## Central Valley Regional Water Quality Control Board

### ***NOTICE OF VIOLATION: WET WEATHER SITE INSPECTION REPORT, RECOLOGY YUBA SUTTER LANDFILL, YUBA COUNTY***

## INSPECTION REPORT

Photo 14: Looking down drainage of northern sumps. Note sump is full and pumps are overwhelmed by volume of discharge from compost area.

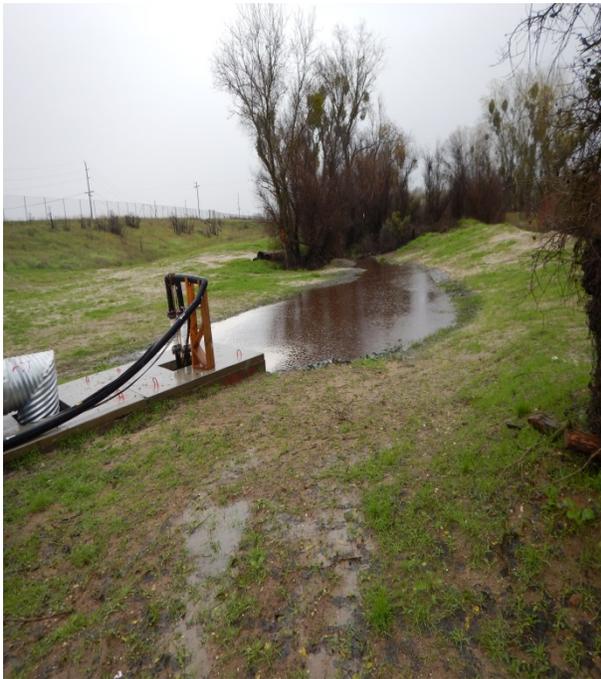
As shown in Photos 13 through 16, staff observed the two northern sumps were full and pumps were overwhelmed by the rate of run-off from the compost area. This unpermitted discharge to the Hog Farm is of an unknown quantity and a violation of the CAO and Title 27, section 20365.

Photo 19: Looking south at the southwestern sump of the compost area. Note significant volume of liquid draining to sump. Also, quality of leachate is different than of quality of leachate shown in the northern part of compost area.

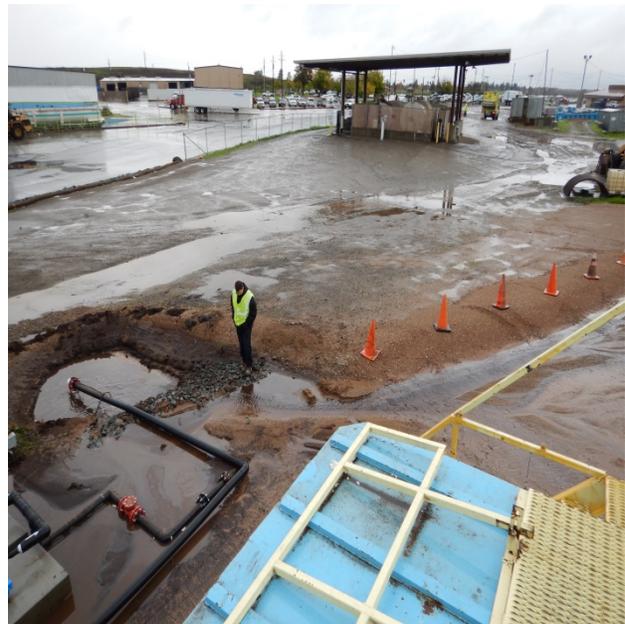
The inspection continued back to the southern Baker Tanks and sumps where areas of concern were observed. Photos 19 through 21 show the southwest sump being overwhelmed by the drainage from the processing area and that pumping from the sump was retarded by sediment transported during the rain event. Photos 22 through 24 show overflowing southern bank of Baker Tanks at capacity during this site inspection.
